**Phase II Report: Independent Scientific Review Panel
on Sediment Impairment and Effects on
Beneficial Uses of the Elk River and Stitz, Bear,
Jordan and Freshwater Creeks**

Authored by the Humboldt Watersheds
Independent Scientific Review Panel

Convened and Facilitated by CONCUR, Inc.
Under the Auspices of the North Coast Regional Water Quality Control Board

Report Prepared August 12, 2003

Figure 6. Figure 18: Background and management-related sediment inputs over time³⁰

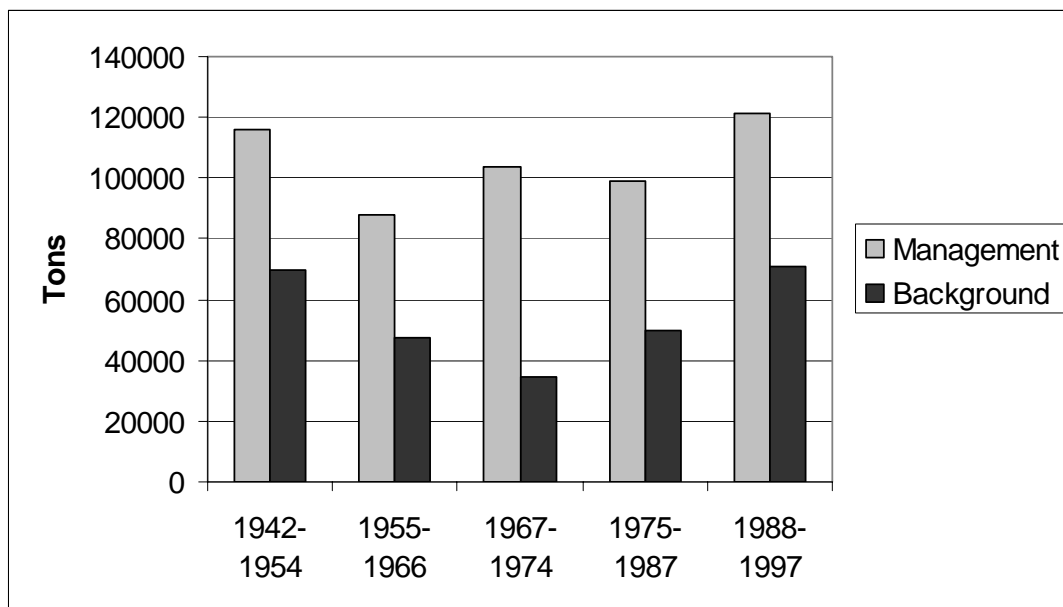
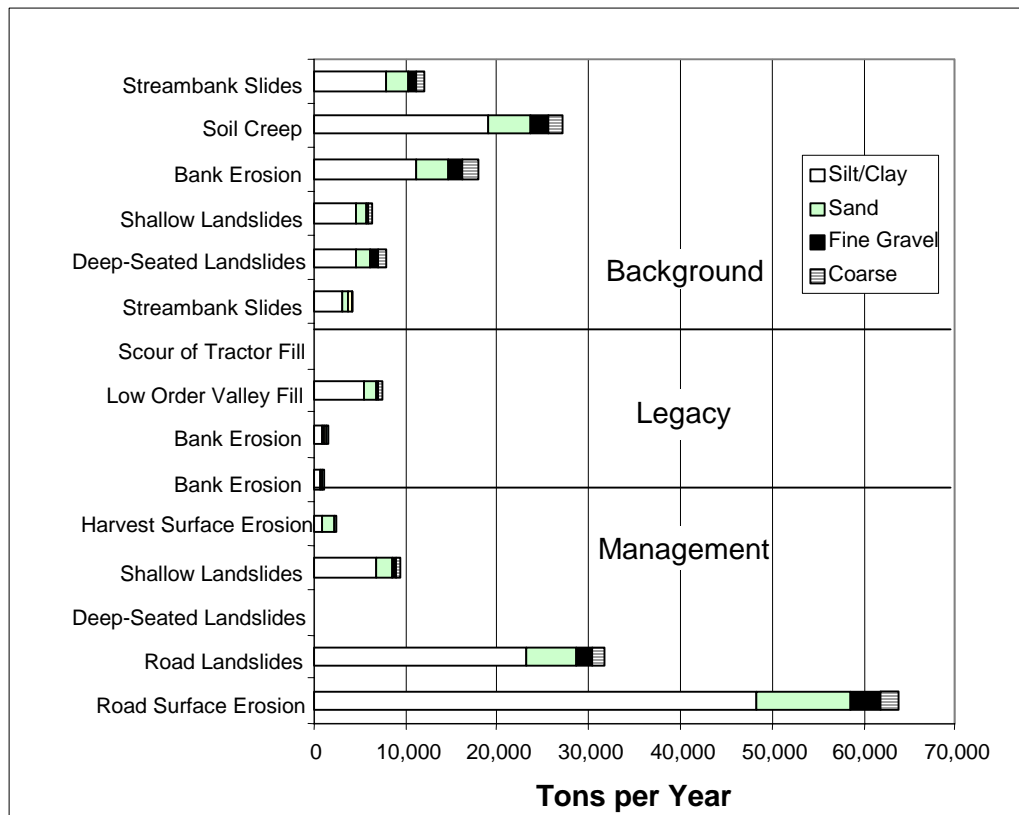
The Watershed Analysis shows that the largest source of management-related sediment load was from roads (88% of management related inputs of which 59% is from surface erosion and 29% is from road related landslides). Shallow landslides in harvest units accounted for another 9% of the management-related input, with the balance due to surface erosion from harvest units and other effects. Figures 18 and 20 from the Cumulative Effects Assessment of the Watershed Analysis illustrate the impact of management on the overall sediment budget (see Figures 6 and 7 below).

In examining these figures it is important to recognize that sediment inputs are averaged over the entire watershed, which comprises impacted (35% harvested in 10 years) and non-impacted area, so the intensity of sediment production from impacted areas is even larger than might be suggested by these figures. The Watershed Analysis identifies the processes responsible (roads and landslides) and mentions the road storm proofing program and thinning versus clear cutting on steeper slopes, but does not provide documentation of the effectiveness of these measures or the effectiveness of other lower impact measures.

Figure 9. Figure 3-4: Acres harvested during second-cycle timber harvest, 1955-1997³³

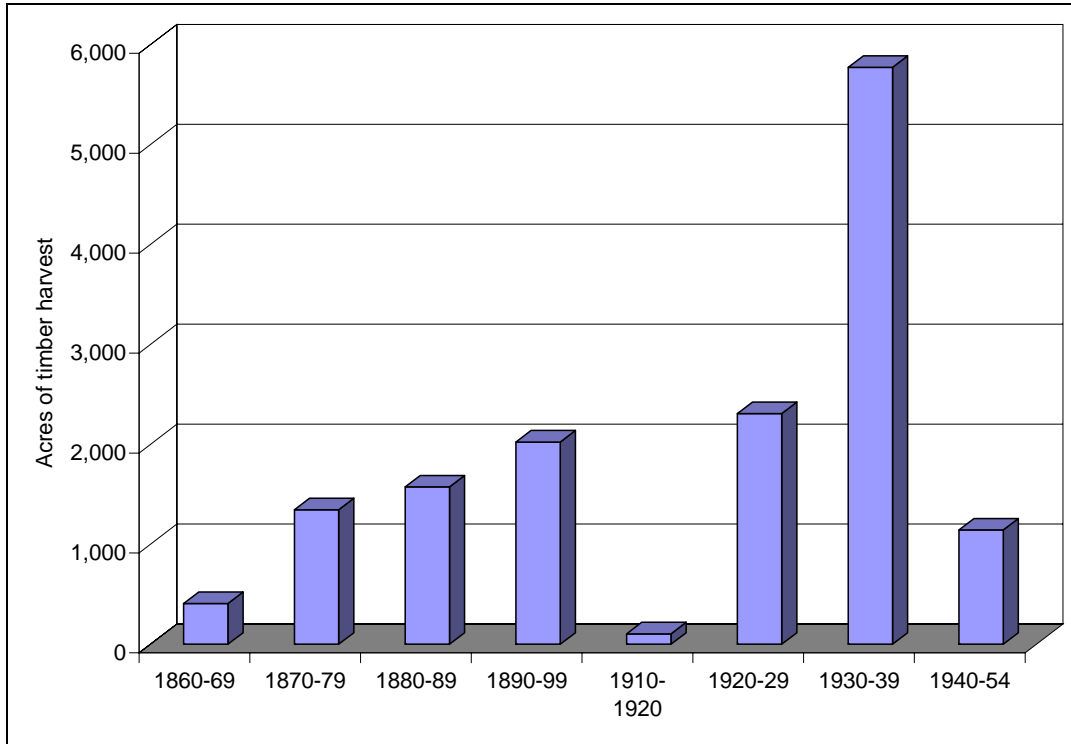
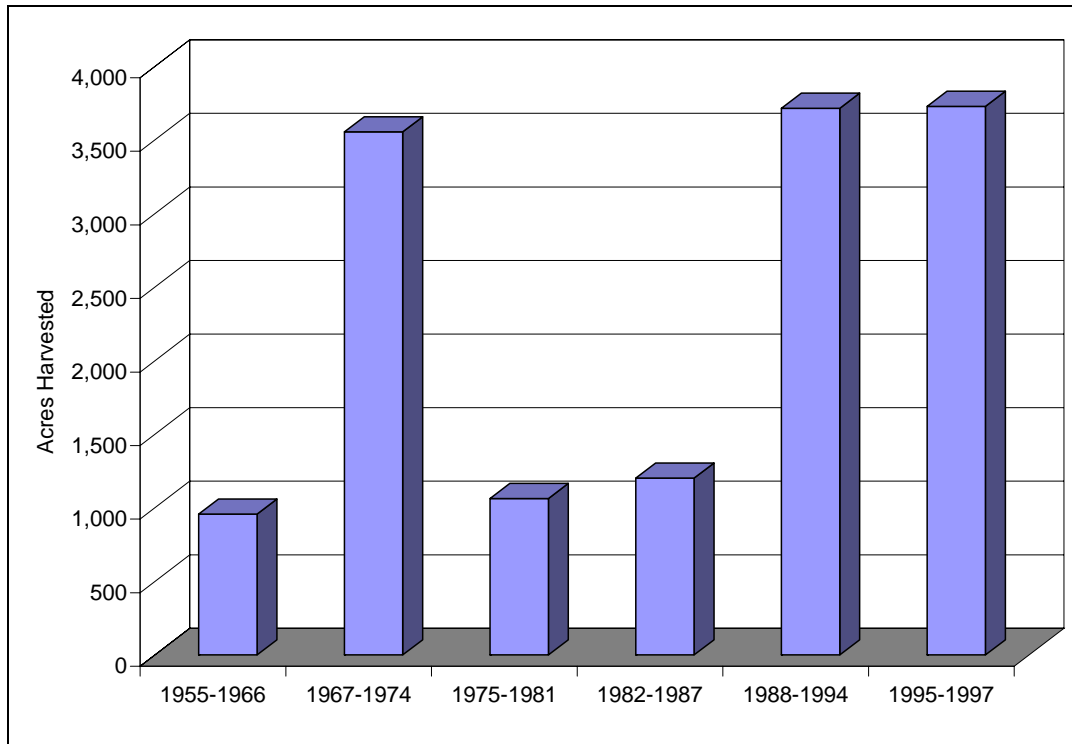
Figure 3-3 and Figure 3-4 from the Watershed Analysis Surface Erosion Assessment document the acres harvested over the history of harvest in Freshwater Creek (see Figures 8 and 9 below). The Panel calls attention to the scales. In the 10-year period (1988-1997) comprising the last two bars on Figure 3-4, the total is over 7,000 acres. This is the highest rate of harvest in the history of this watershed.

This fact is not immediately apparent in the presentation of these figures, which are reproduced here exactly as they are depicted in the Watershed Analysis. In Figure 3-3, 10-year intervals are used to show acres harvested over time, but in Figure 3-4, the 10-year period from 1988 to 1997

is reported using two bars, with 3,500 acres harvested shown in each block. Together the total number of acres harvested in 1988-1997 is 7,000, higher than any previous 10-year period. The two intervals used to report this last 10-year period are comprised of a 7-year and a 3-year interval, both of which show a harvest area of 3,500 acres, so the harvest rate for the last 3-year interval reported is more than 1,100 acres per year. This is more than double any previous harvest rate presented in these two graphs.

Figure 10. Figure 4-1: Miles of new road construction by aerial photo period³⁴

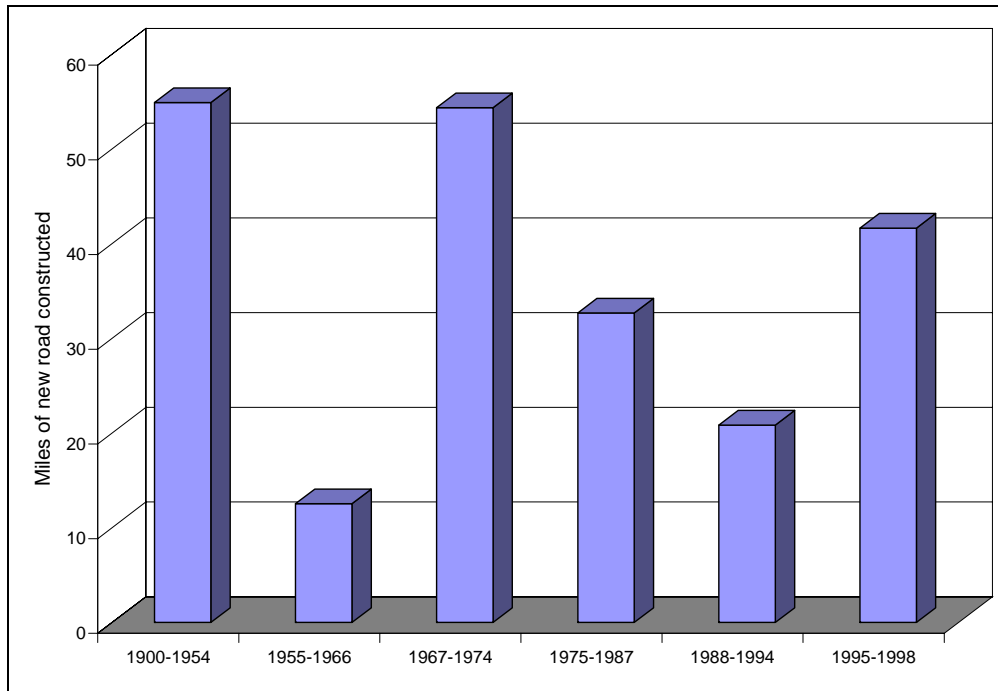
Roads are responsible for the largest component (88%) of management sediment production. Figure 4-1 from the Surface Erosion Assessment (see Figure 10 below), reports new road construction. The Panel calls attention to the years that apply to each bar. The rightmost bar indicates that 40 miles of new road were constructed in the last four years of the analysis (1995-1998) for a rate of 10 miles/year. The highest average rate in all periods prior to this was 52 miles in the 8-year period 1967-1974, for a lower rate of 6.5 miles/year. Concurrently with harvesting this watershed is also undergoing significant road construction rates. Given the way in which the data was graphed, this high rate of road construction for the latest period may not be immediately apparent.
